# NextEra Energy Transmission West and Pacific Gas and Electric Company Estrella Substation and Paso Robles Reinforcement Project Proponent's Environmental Assessment (A.17-01-023)

## Response to Deficiency List No. 2

Exhibit 3.16-3. Preliminary Construction Activity Timeline

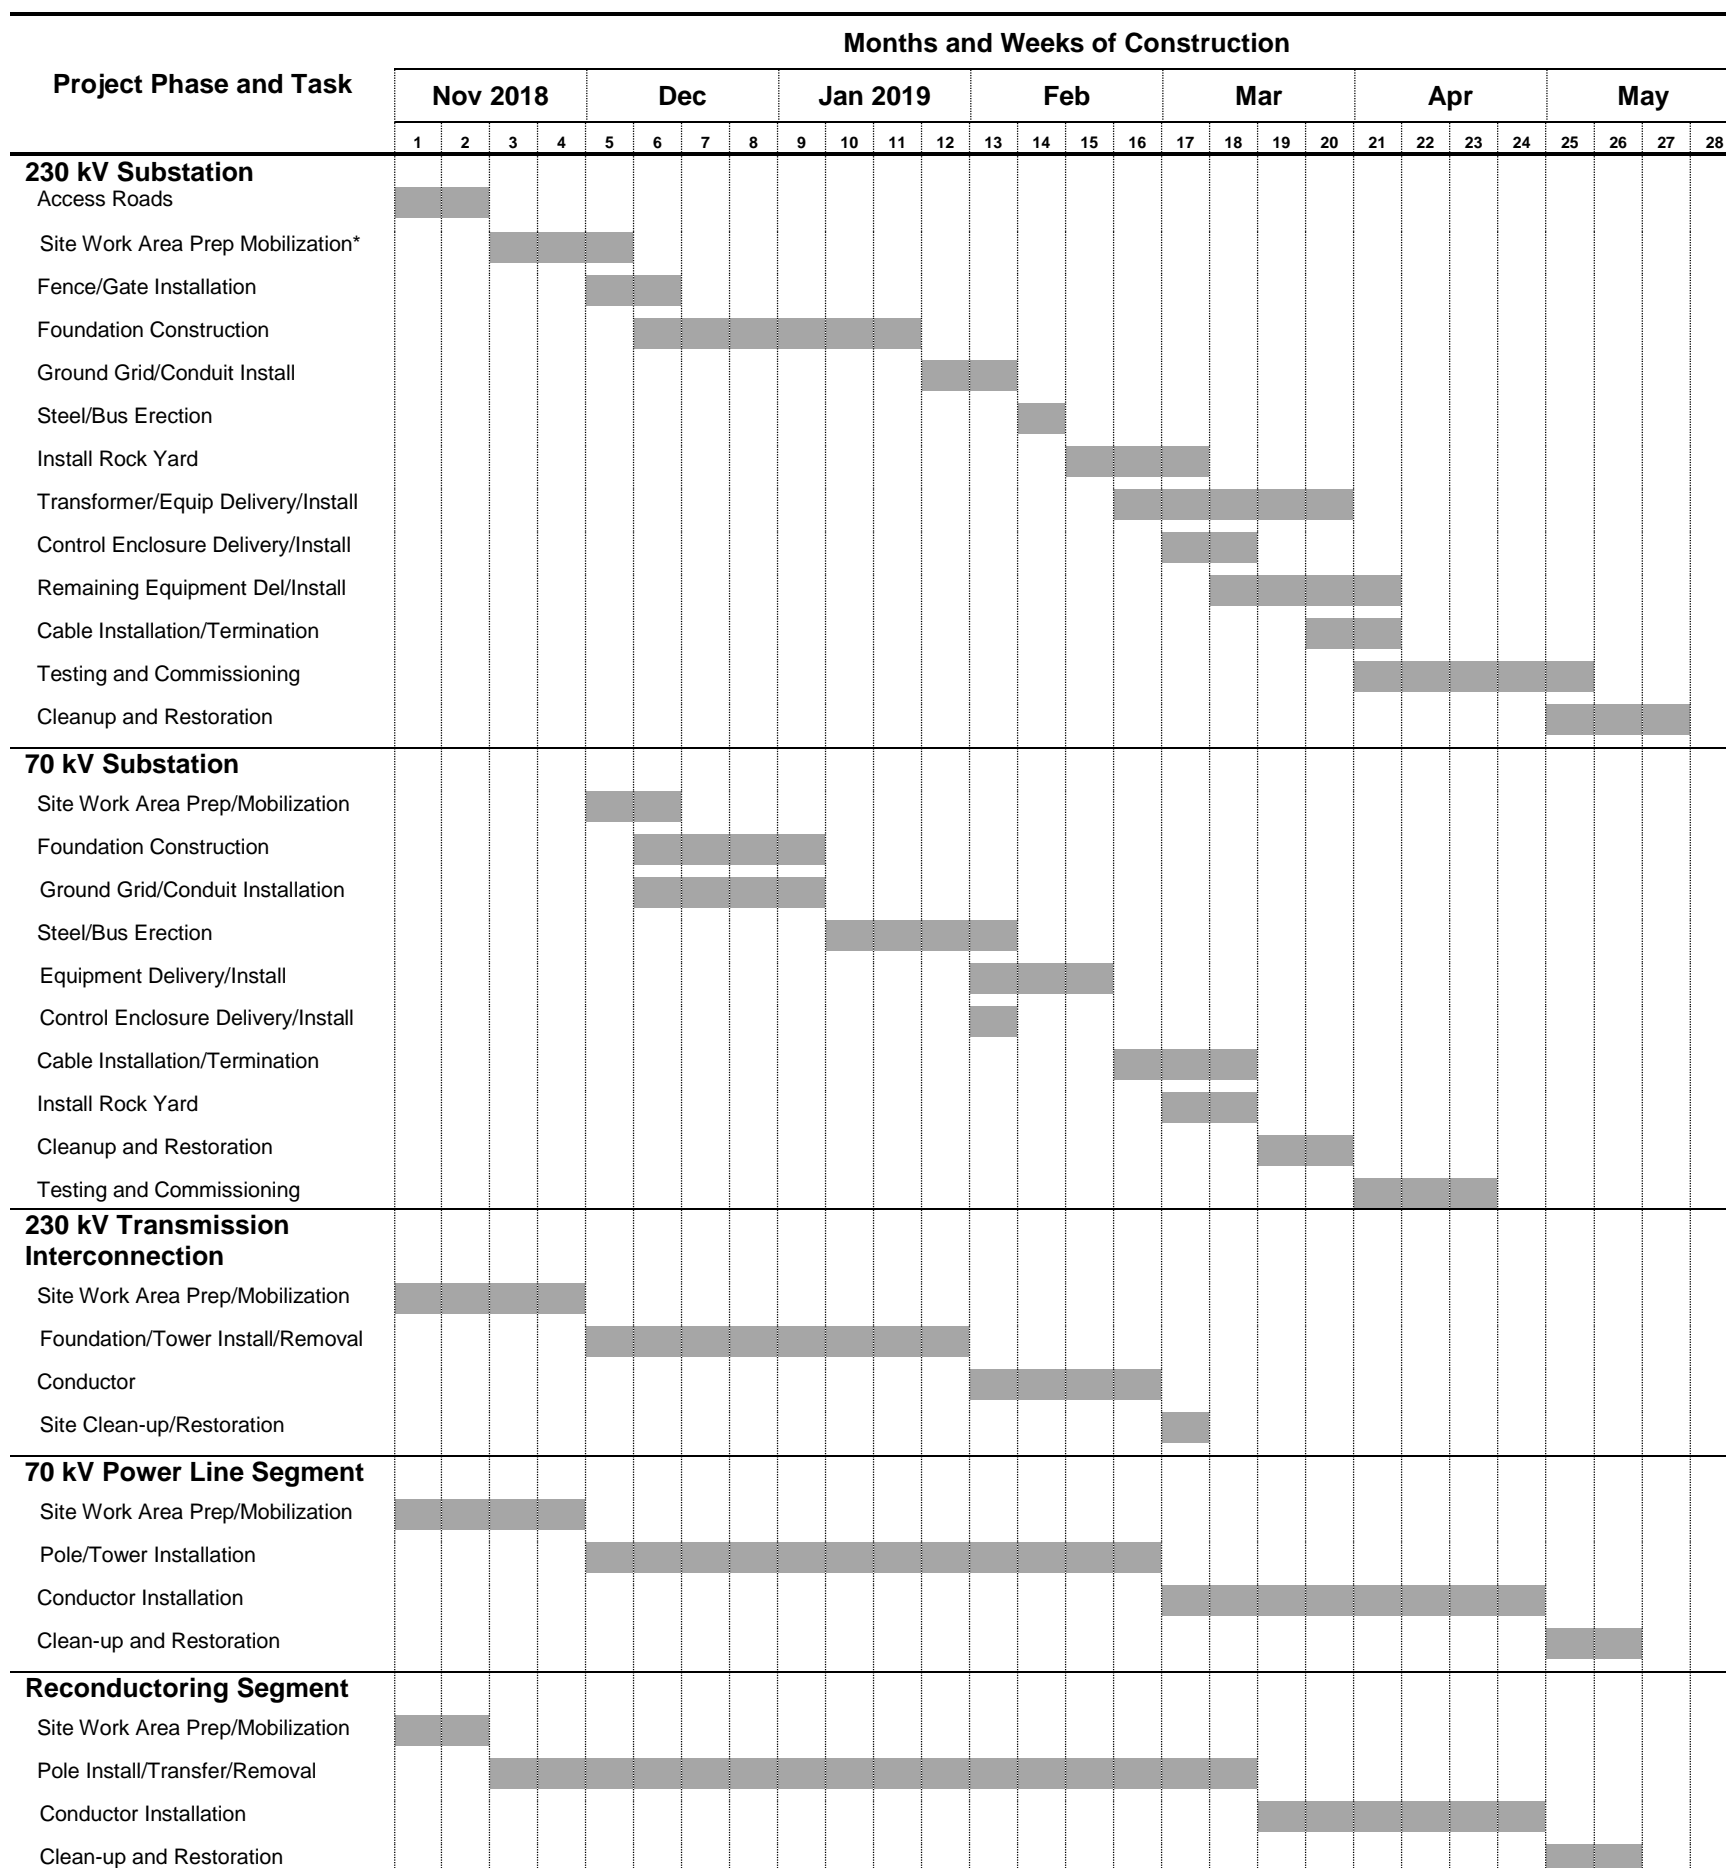
*Please provide the schedule of activities and generated trips. Also, please explain whether the generation of trips for the transformer installation will coincide with the generation of trips for the Estrella substation. If so, please add the trips generated by the simultaneous tasks together.*

See response to Deficiency 3.16-3. PEA Tables 3.16-6 and 3.16-8, Estimated Daily Worker and Truck Trips for Construction of Estrella Substation and the Power Line provide an updated schedule of activities and generated trips. Exhibit 3.16-3, Preliminary Construction Activity Timeline, is provided below and illustrates the tasks that are simultaneous.

Trips generated by the simultaneous tasks were already added together in the PEA analysis. Trips for construction of Estrella Substation include all phases of substation construction. The generation of trips for the 5-week long transformer installation phase coincides with other phases of the 230 kV substation, 70 kV substation, and 230 kV transmission interconnection construction.
